BOARD ACTION REPORT – APPEALABLE ITEM

Project Name: 7-Eleven

Project Location: 16000 S. Military Trail

SITE PLAN REVIEW AND APPEARANCE BOARD STAFF REPORT

3 ELEVATION - FACING NORTHEAST
3/16" = 1'-0"

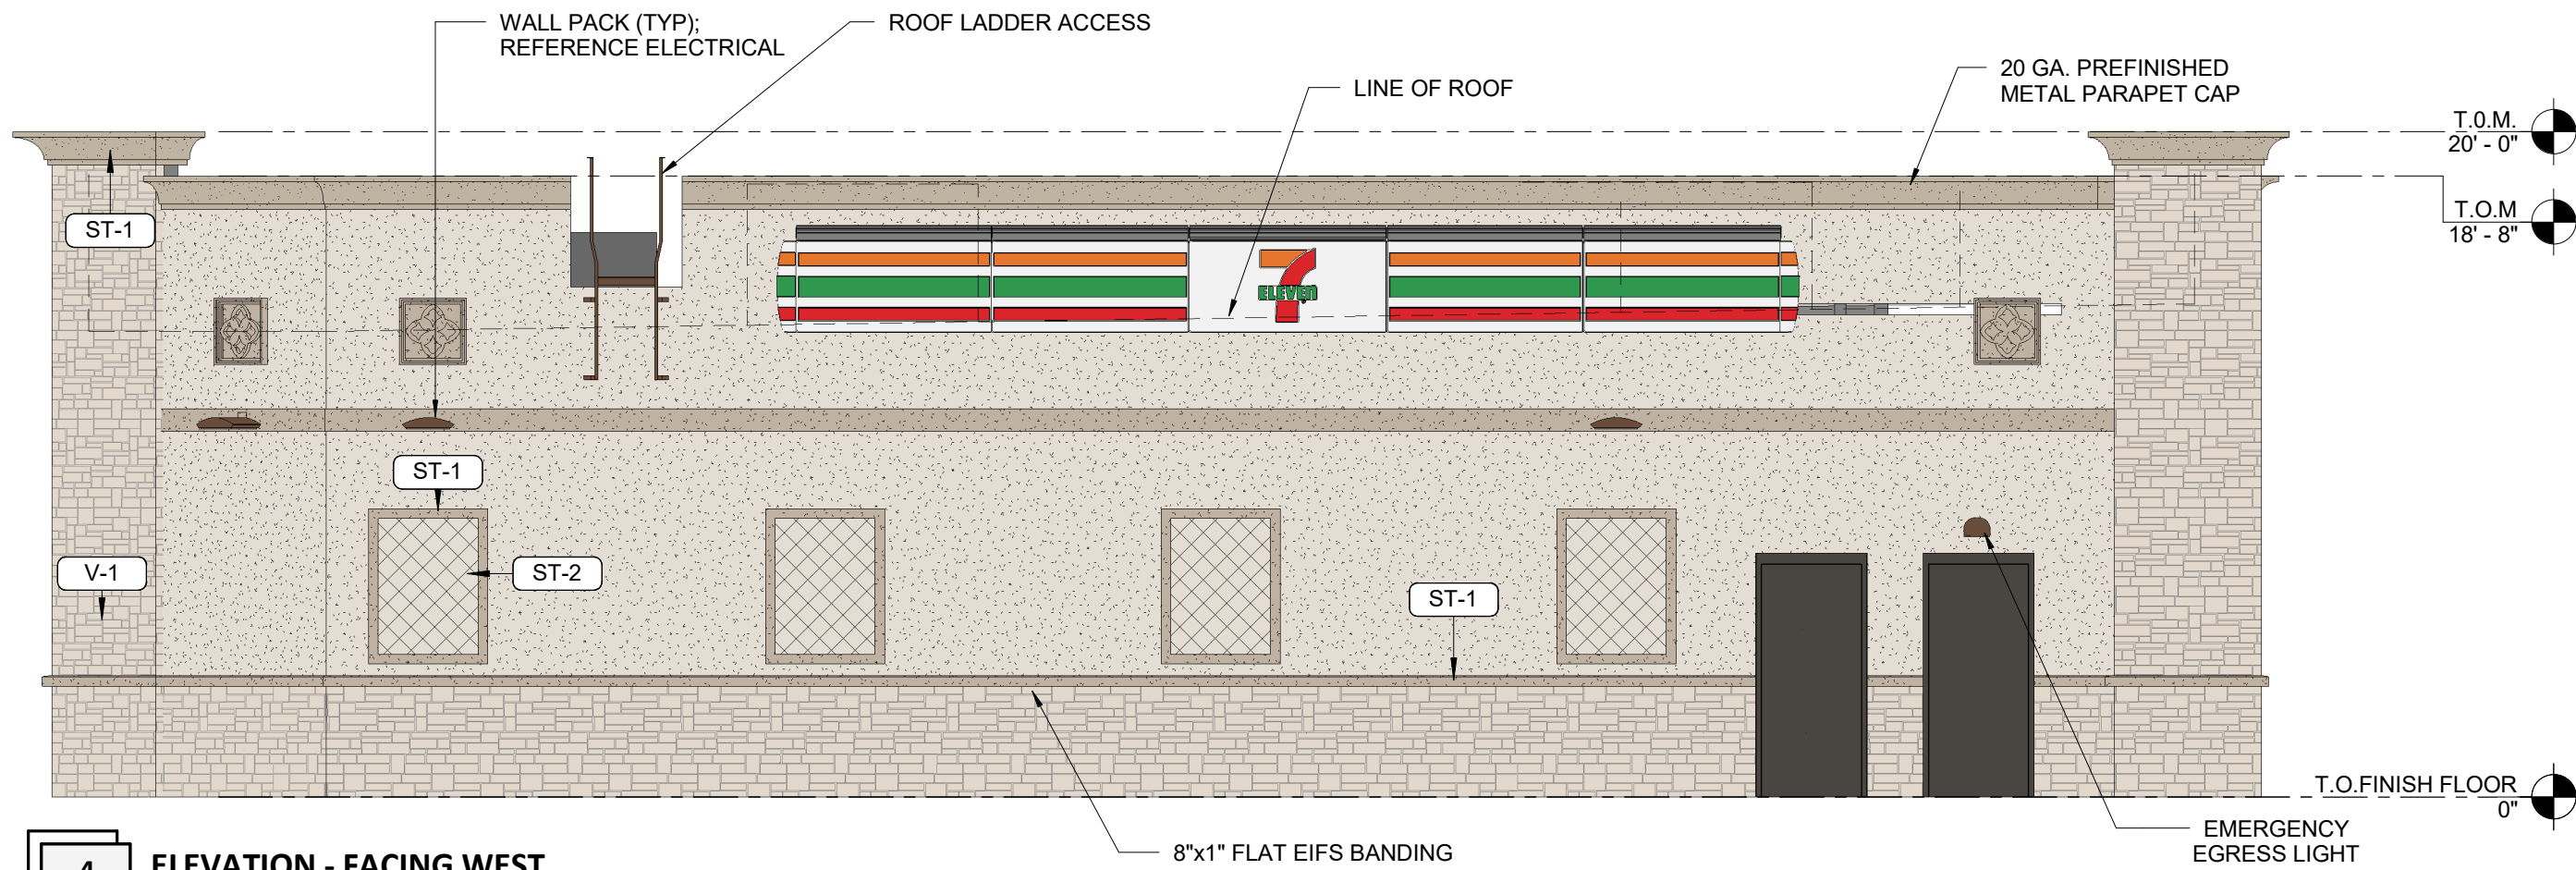
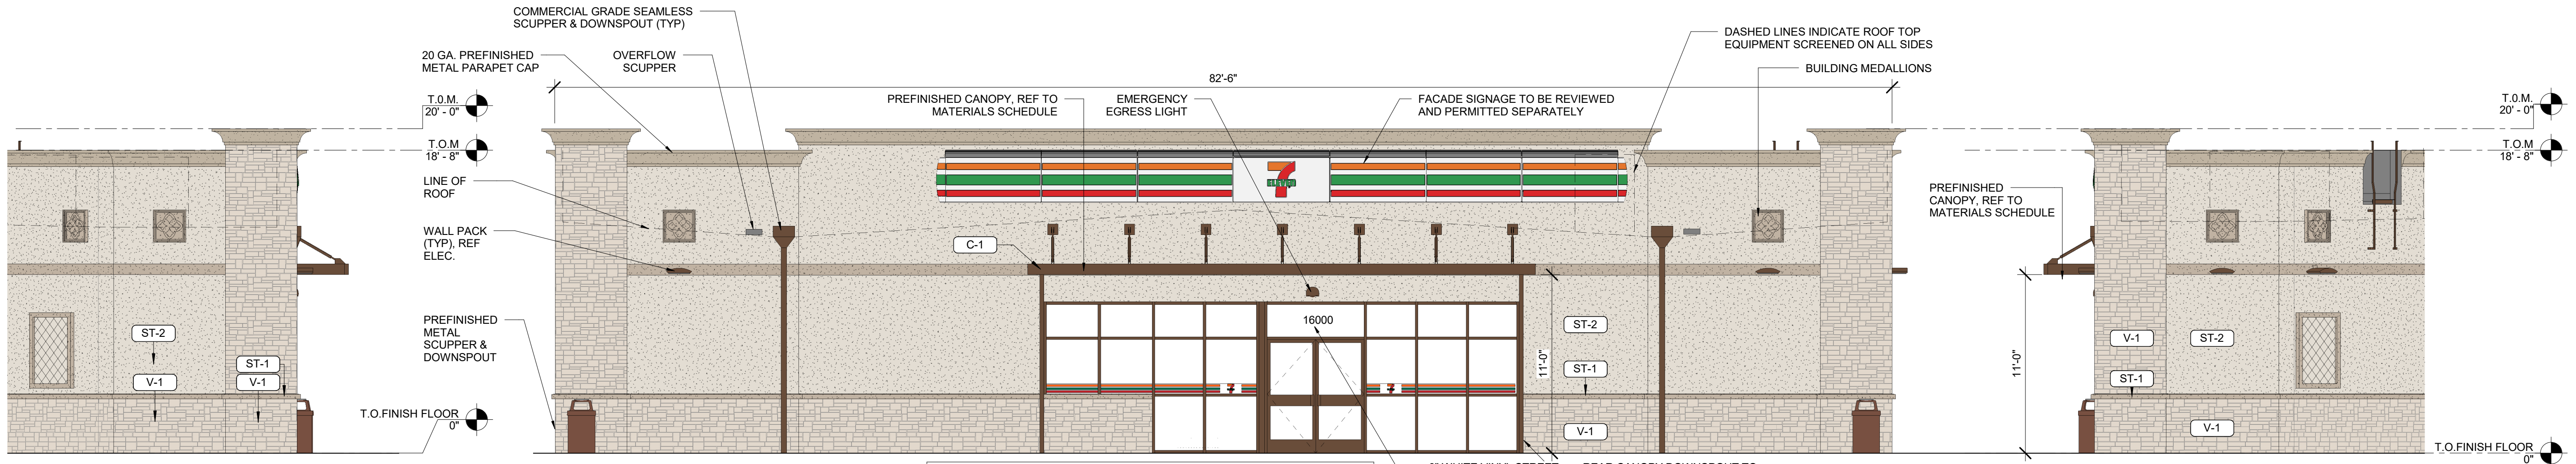
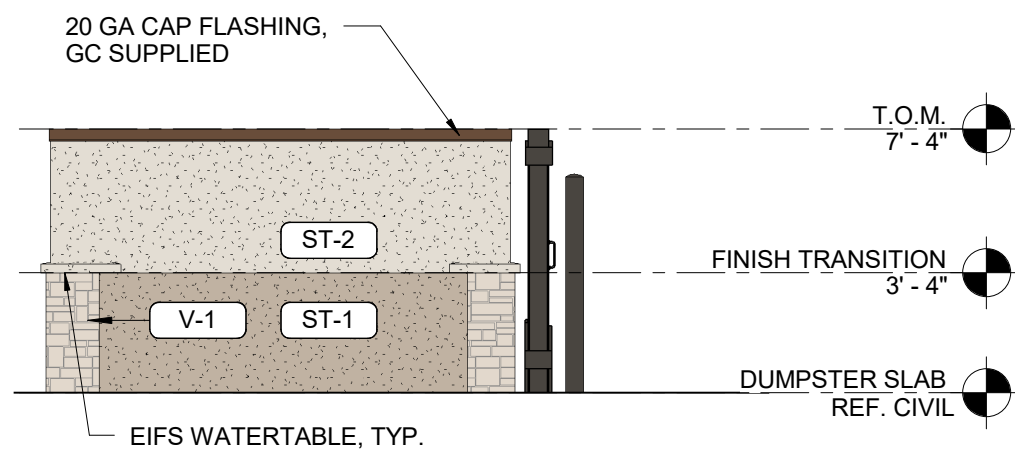
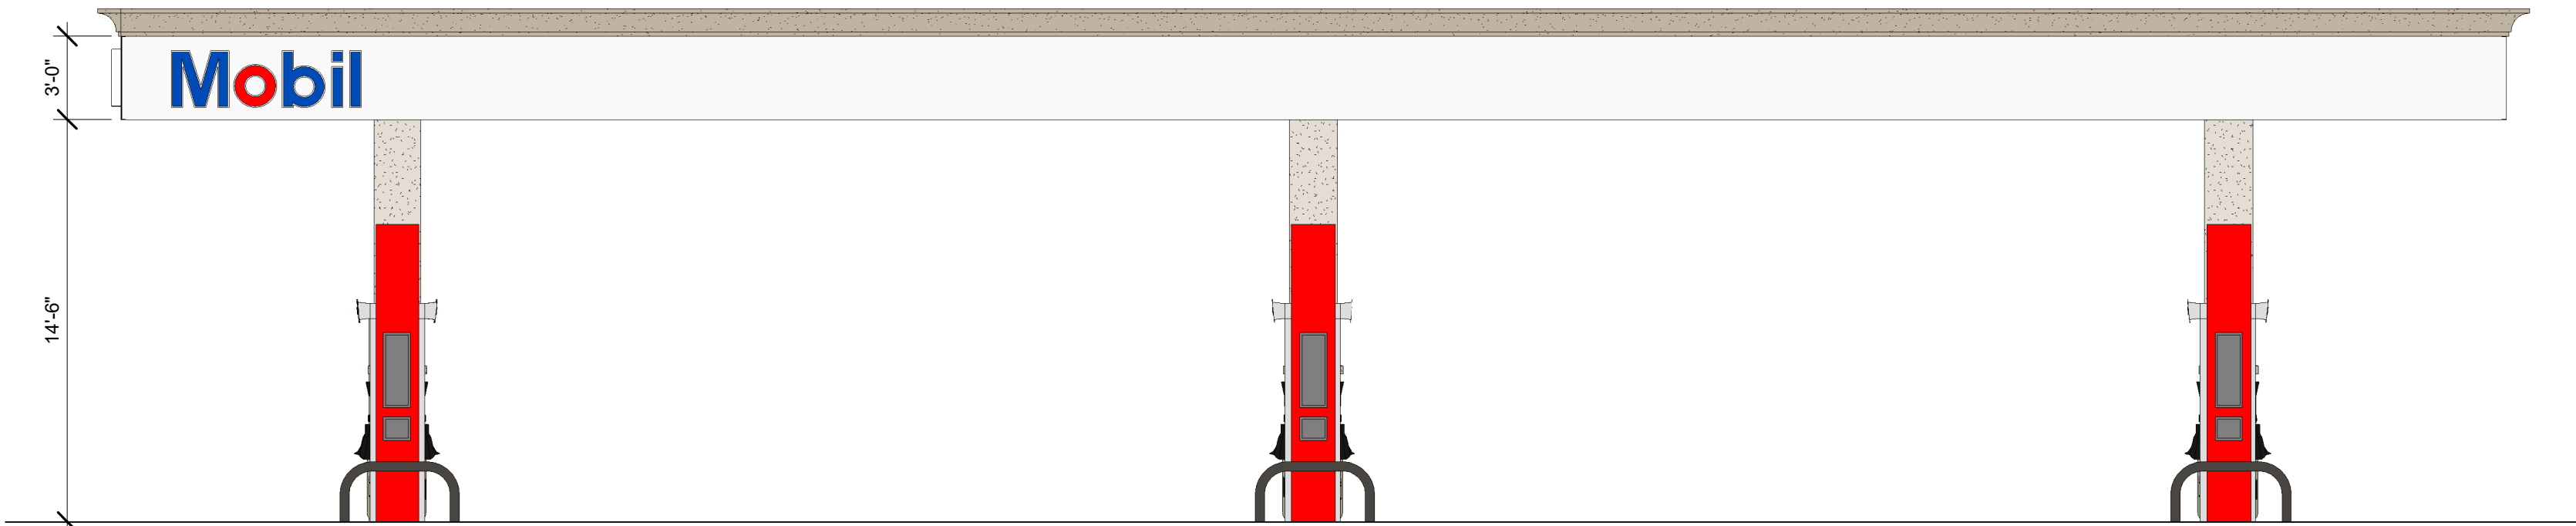
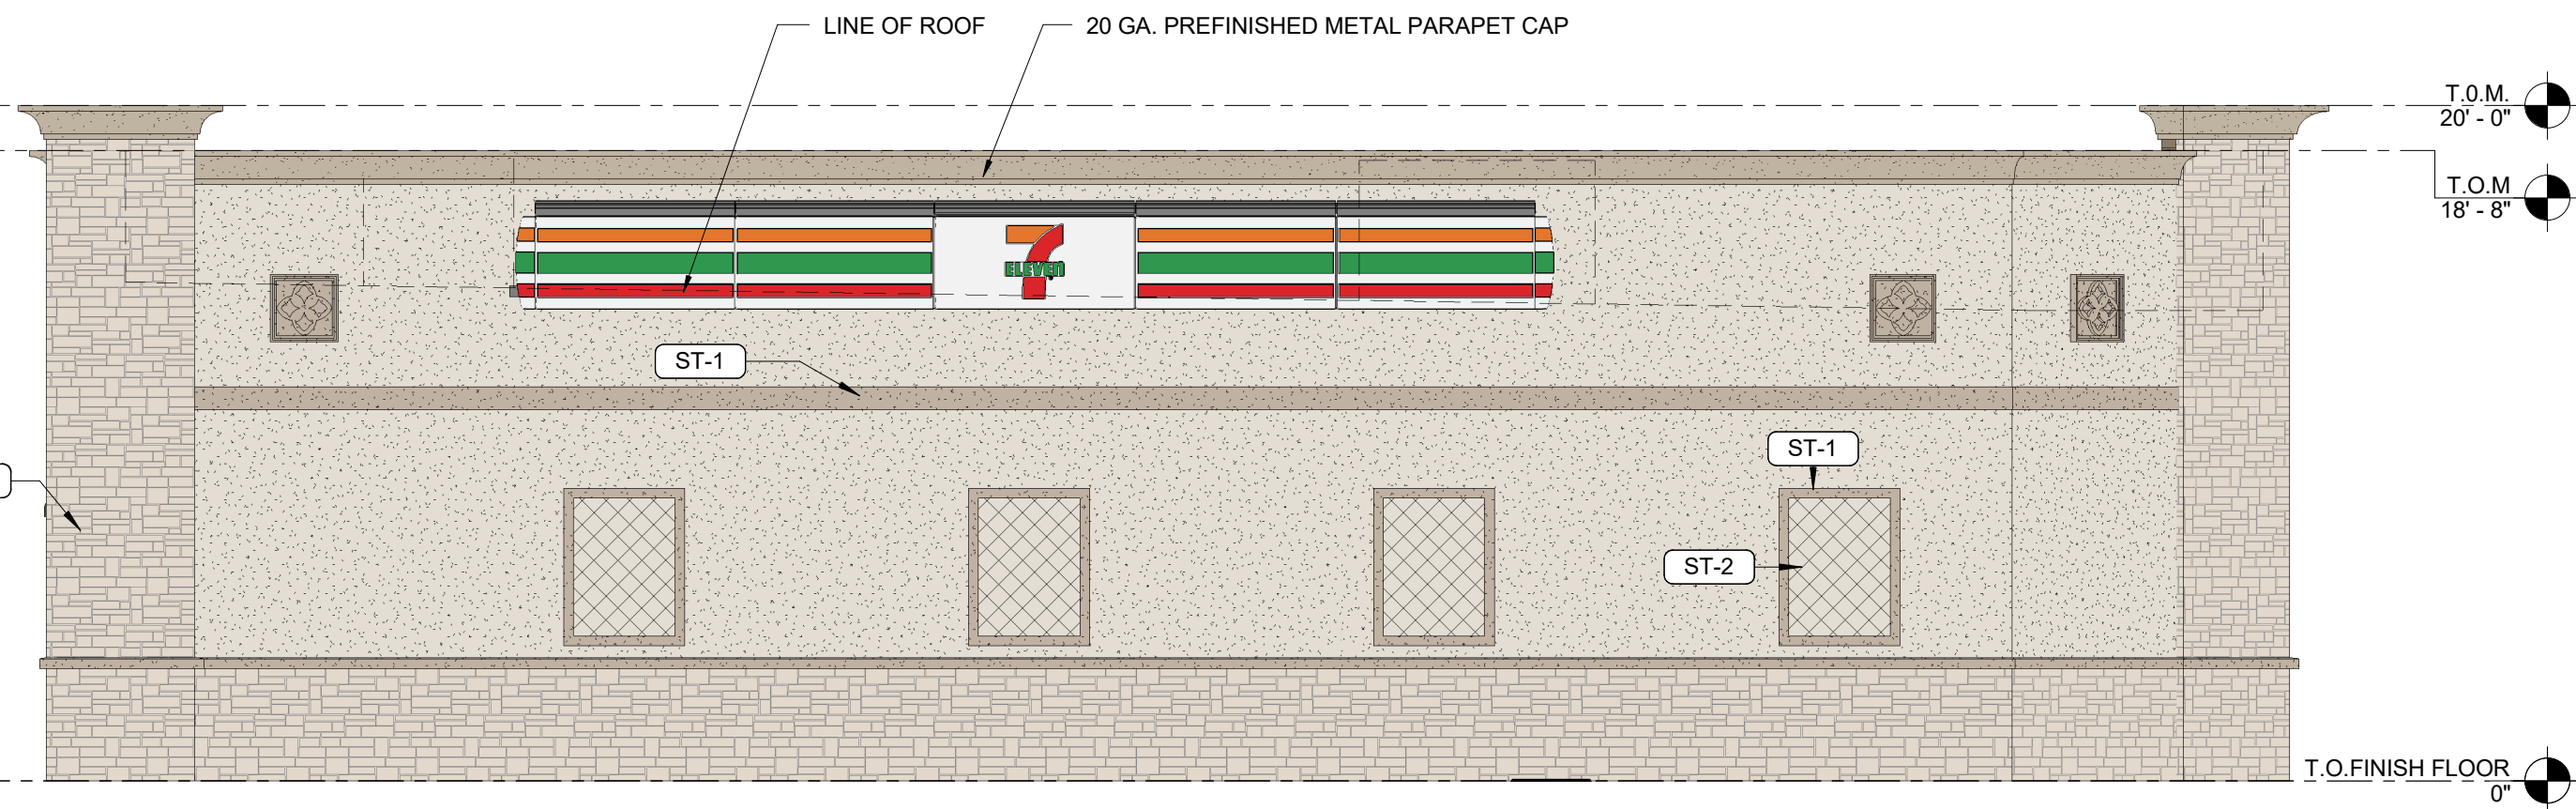
The elevations are generally in good taste and will not materially depreciate the surrounding environment. The existing center is dated but the earth tones and wall material of the proposed structure are consistent with the existing buildings. Additional detailing has been added to the facades that face the right-of-ways to give the building some visual interest from that perspective. The canopy has been designed to blend with the façade of the proposed structure utilizing like colors, materials and textures. Therefore, positive findings can be made with regard to the criteria listed in LDR Section 4.6.18(E).

8 FRONT ELEVATION - DUMPSTER ENCLOSURE
3/16" = 1'-0"

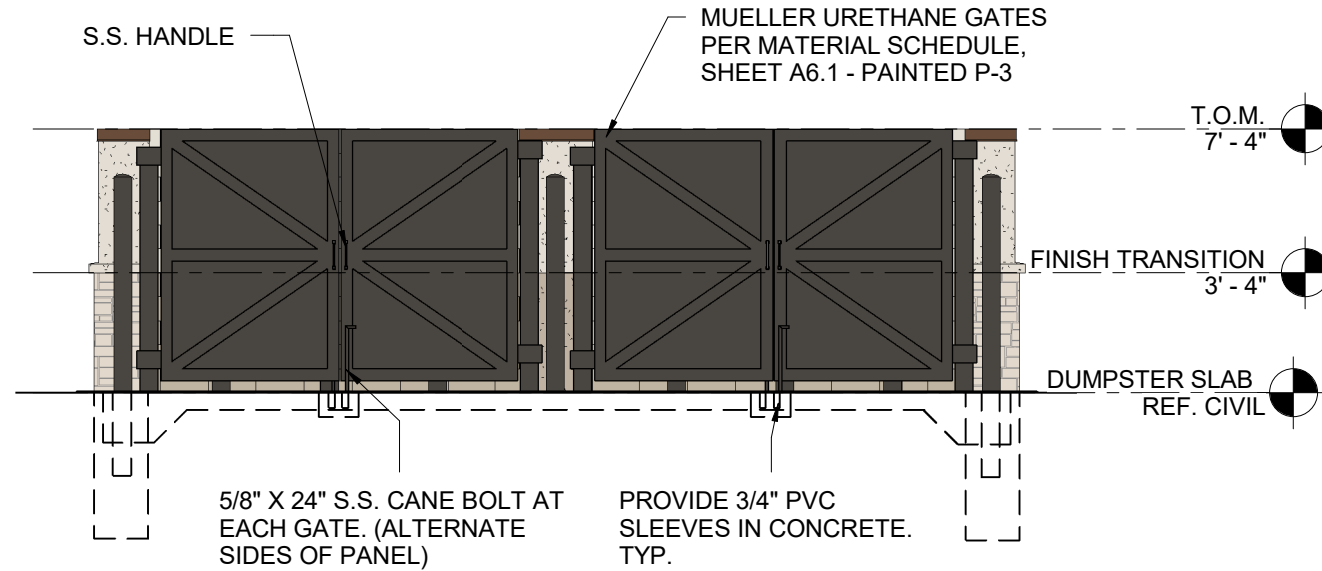
Pursuant to LDR Section 4.6.6(C)(1), dumpsters, recycling containers and similar service areas must be enclosed on three sides with vision obscuring gates on the fourth side, unless such areas are not visible from any adjacent public rights-of-way. The refuse enclosure does not face a public right of way but faces the interior of the subject parcel. The area is enclosed on three sides and provides gates, meeting the code requirements.
